**ADDENDUM NO. 1**

**SUBJECT:** ITB 2018-812 Turnagain Elementary School Interior Upgrades

**Turnagain Elementary School - Interior Upgrades**  
3500 W. Northern Lights, Anchorage, Alaska  
ASD Project No. 380015  
ENLARGED REMODEL PLANS, MECHANICAL DETAIL

**1 ENLARGED KITCHEN BELOW FLOOR PIPING PLAN**  
1/4"=1'-0"

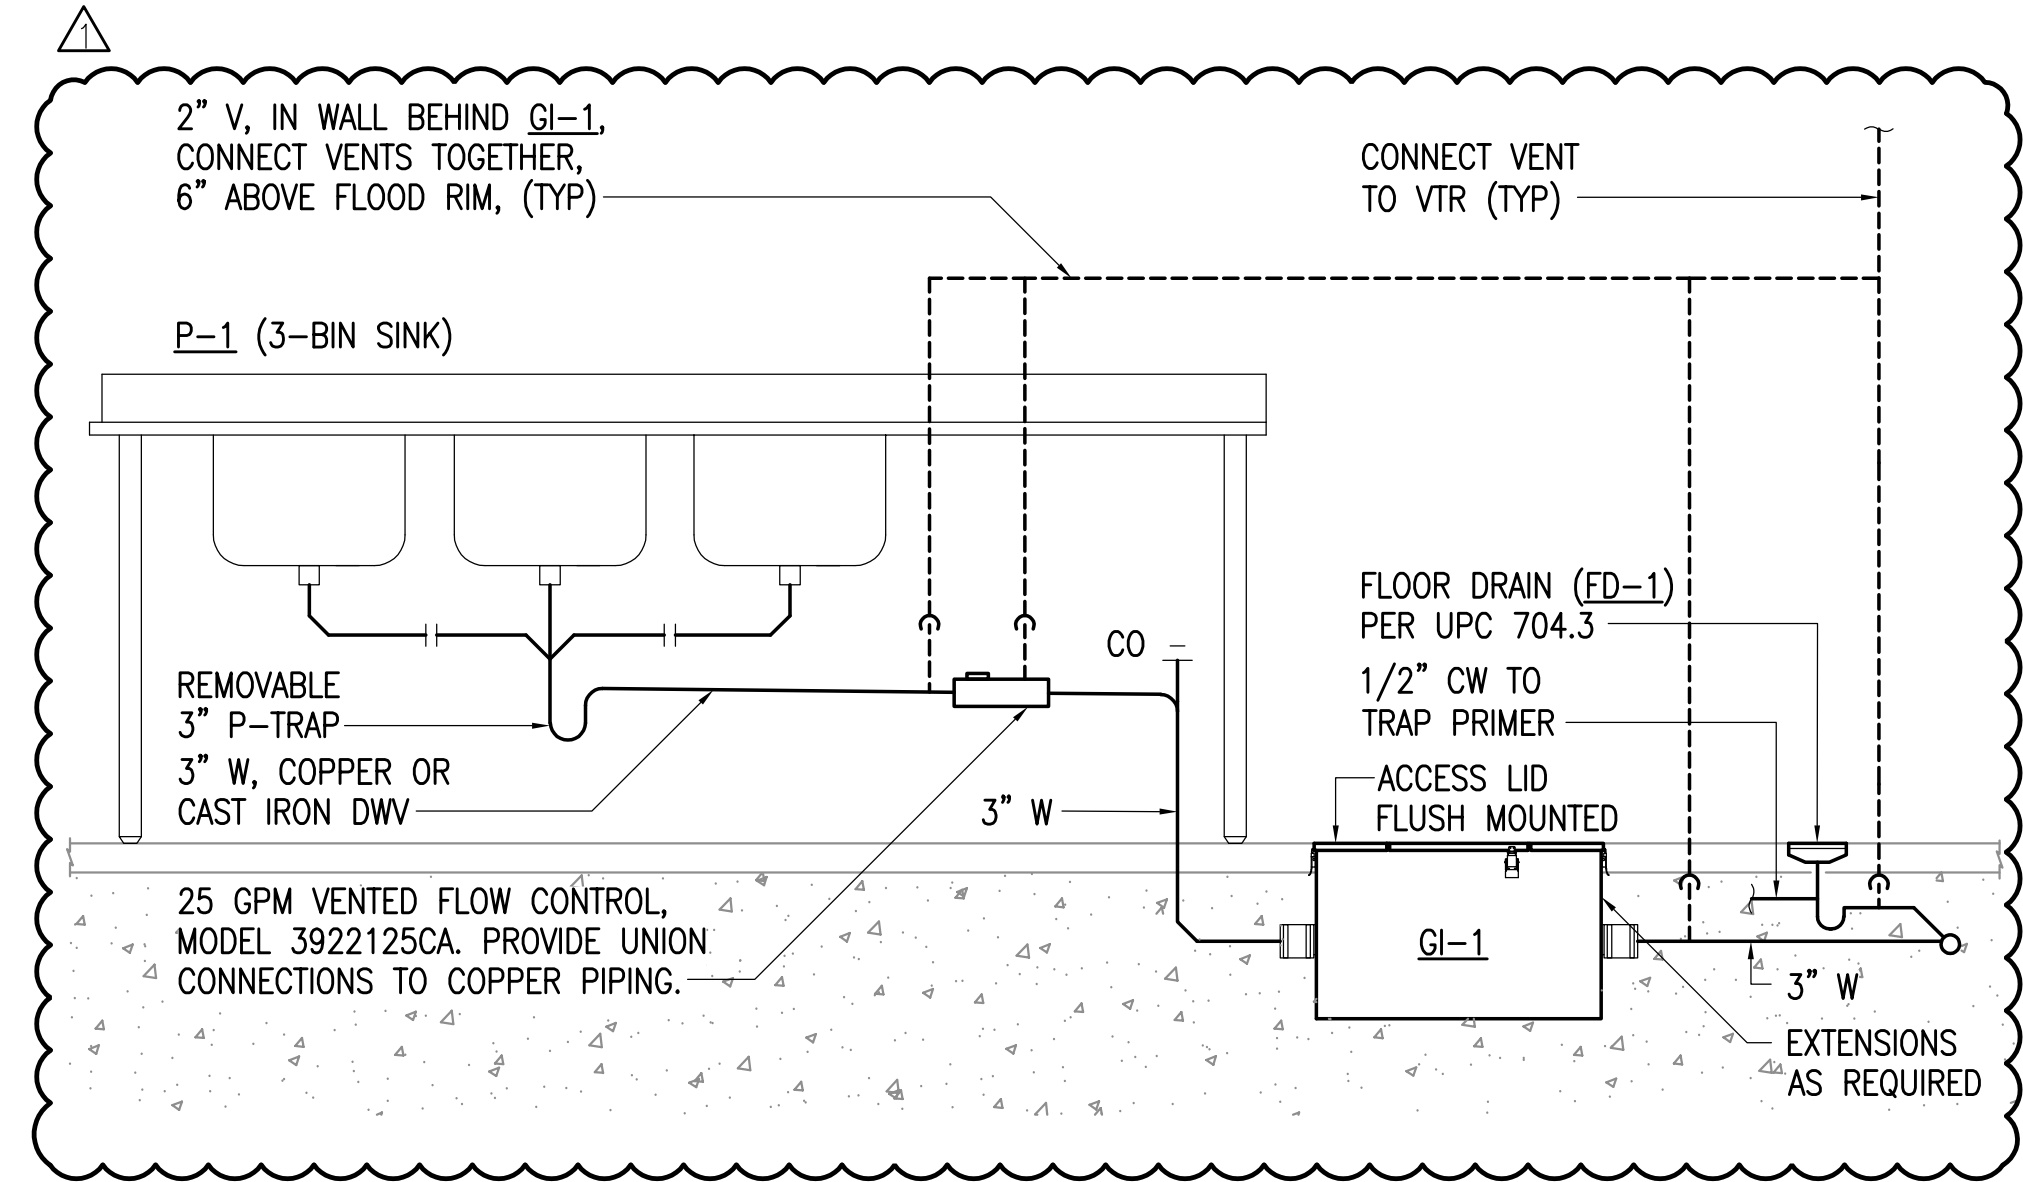
- Q5:** The grease interceptor requires a downstream vent which would be located before the floor drain. (UPC 1014.2.2)  
**A5:** RSA Response: A downstream vent for the grease interceptor has been added. Details 1, 2, and 3 of Sheet M2.2 have been revised.

**3 GREASE INTERCEPTOR (GI-1) PIPING SCHEMATIC**  
NO SCALE

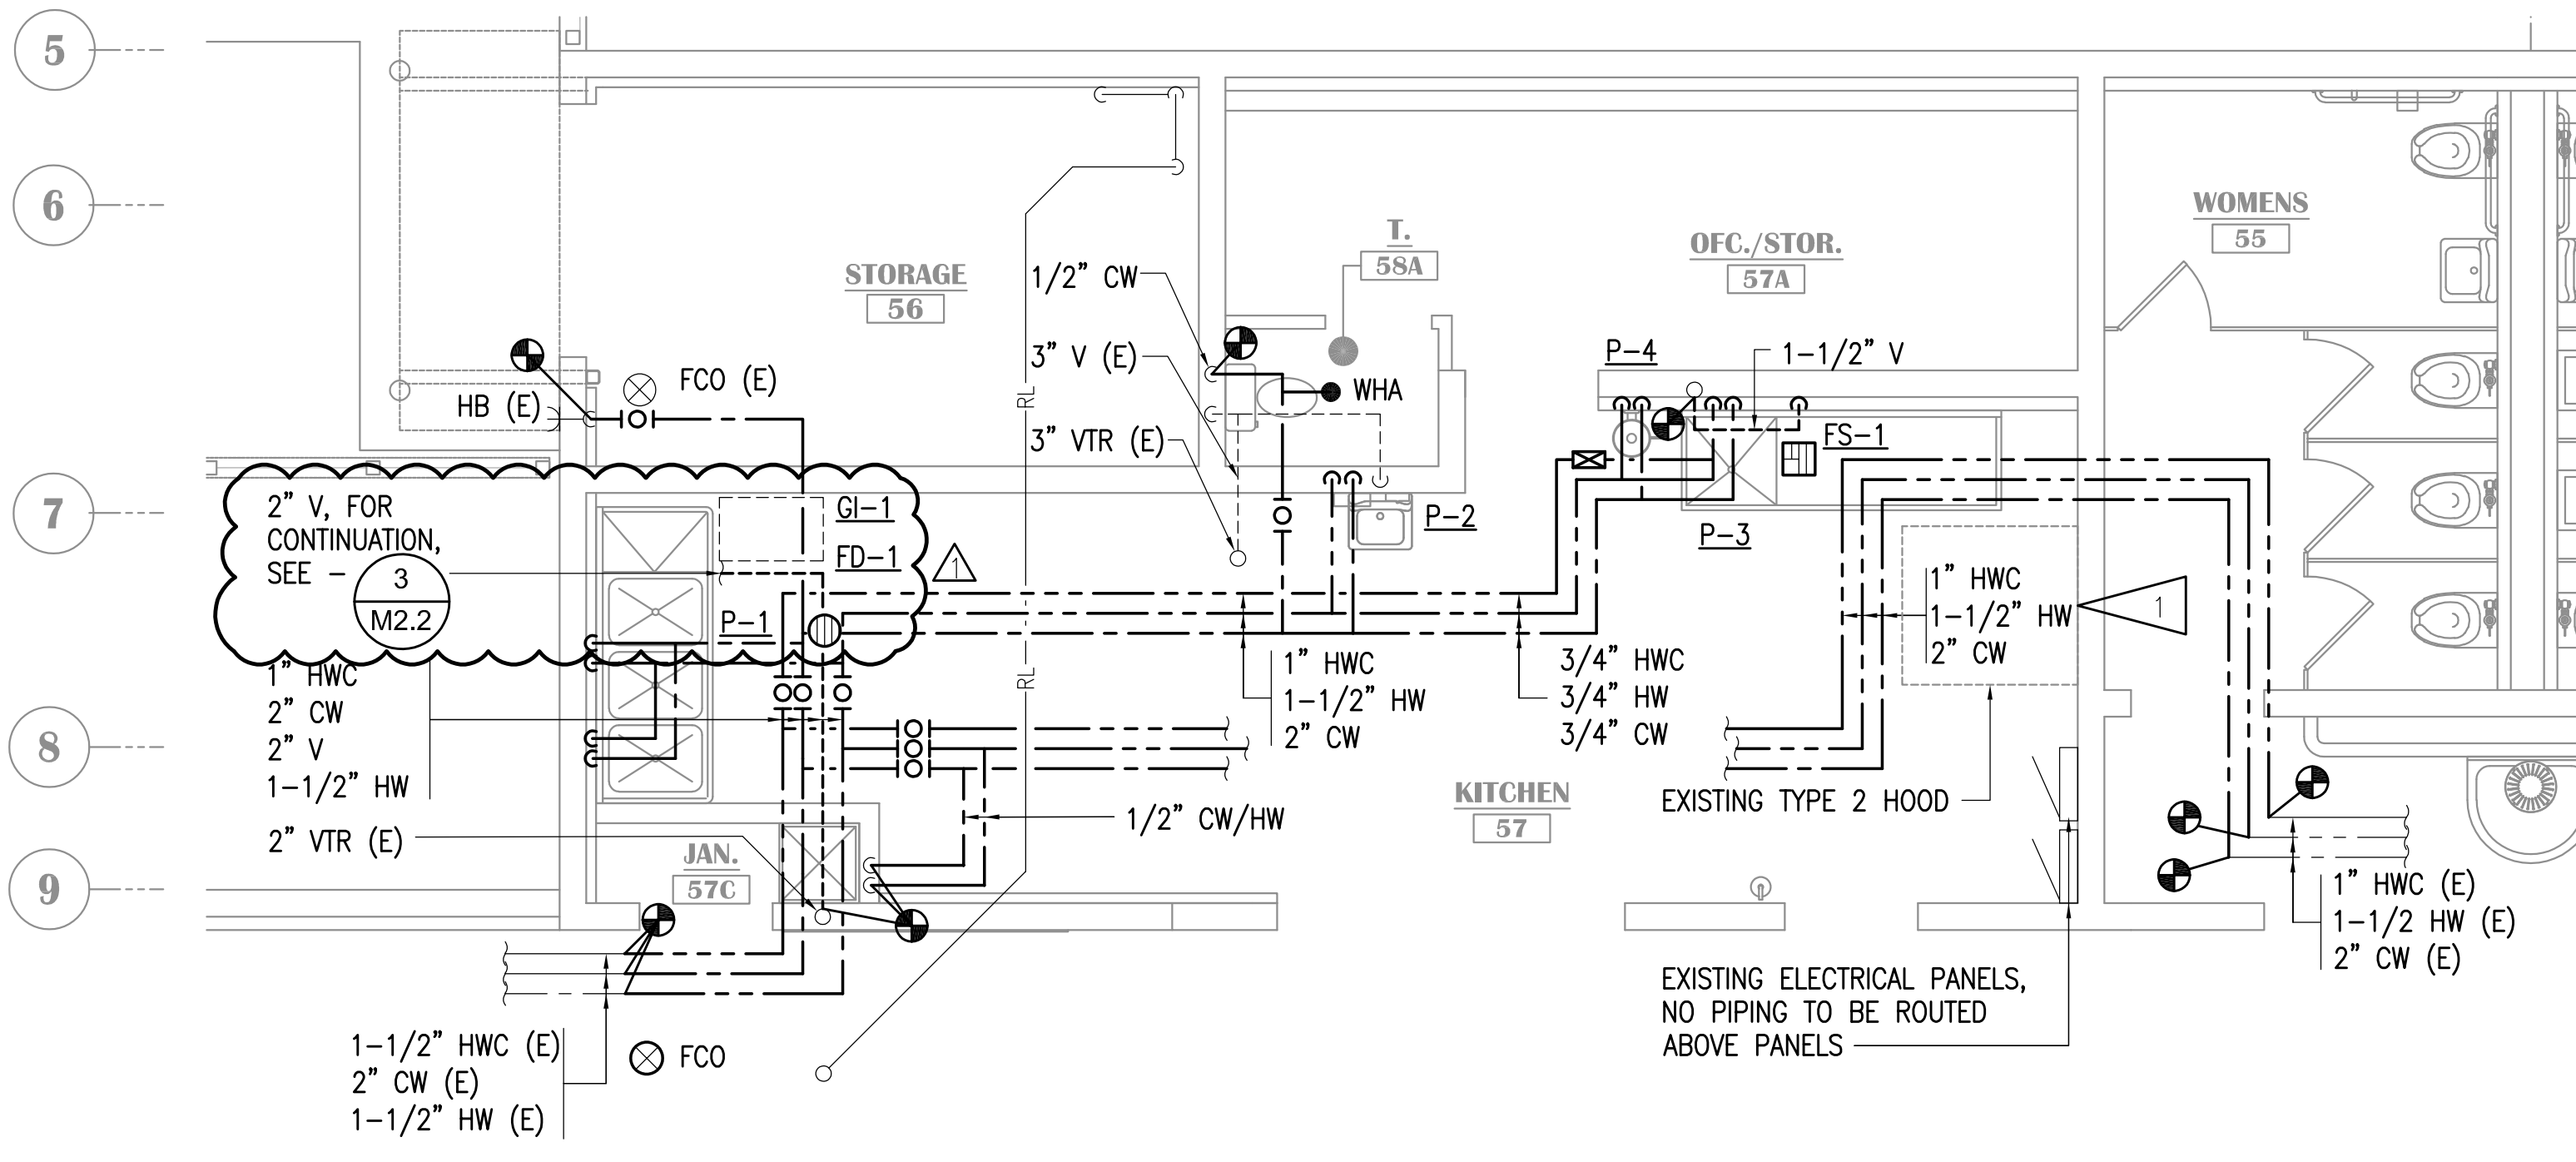
- Q1:** The 3-compartment sink requires a center waste outlet. (UPC 1001.1)  
**A1:** RSA Response: The three-compartment sink will have a center waste outlet per the revised Detail 3/M2.2.

- Q2:** The vents for the three-compartment sink and the floor drain are required to be off the trap arm.  
**A2:** RSA Response: The respective vents of the three-compartment sink and the floor drain will be off the trap arm per the revised Detail 3/M2.2.

- Q3:** The flow control fitting vent comes directly off of the fitting.  
**A3:** RSA Response: The flow control fitting vent will come off of the fitting per the Detail 3/M2.2.

- Q4:** The flow control fitting requires access.  
**A4:** RSA Response: The flow control fitting will be located above floor per the revised Detail 3/M2.2.
